Item Name: Replacement Skidtube with Run-on Landing Wearplates Fits LH or RH **Stop** *NS2*

DESIGN		DART AEROSPACE LTD HAWKESBURY, ONTARIO, CANADA
DRAWN	RF	
CHECKED		DRAWING NO. REV. E
MFG. APPR.		D2580 SHEET 1 OF 8
APPROVED		TITLE SCALE
DE APPR.		205 SKIDTUBE ASSEMBLY NTS
DATE	11.06.21

DRAWING NO	TITLE	REV. E	DART AEROSPACE LTD	D.E.O. NO.	SHEET NO.	SCALE
D2580	205 SKIDTUBE ASSEMBLY		ENGINEERING ORDER	D2580-E-1	SHEET 1 OF 1	NTS

PURPOSE:
CHANGE ALL C'BORED WELDED CROSSBOLT SPACERS TO SWAGED SPACERS

SECTION B-B, F-F, I-I
NOT TO SCALE

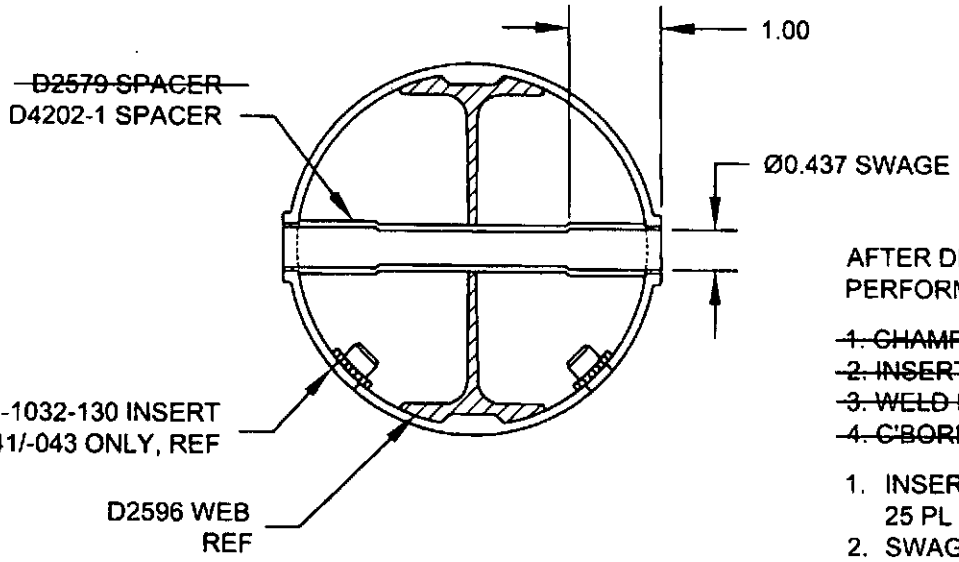
SECTION B-B, SECTION F-F, & SECTION I-I ARE AMENDED AS FOLLOWS
FOR ALL HOLES THAT WERE ORIGINALLY C'BORED:

AFTER DRILLING AND BENDING ASSEMBLY
PERFORM THE FOLLOWING FOR Ø0.508 HOLES ONLY:

~~1. CHAMFER HOLE 0.050 X 45°~~
~~2. INSERT D2579 SPACER (20 PLACES)~~
~~3. WELD INTO PLACE AND GRIND FLUSH~~
~~4. C'BORE D2579 SPACER TO Ø0.437 X 1.00 DEEP~~

1. INSERT D4202-1 SPACER, 20 PL (-041) OR 20 PL (-045) OR 25 PL (-047)
2. SWAGE TO Ø0.437 X 1.00 DEEP PER QSI 002
3. TRIM / GRIND FLUSH PER QSI 002
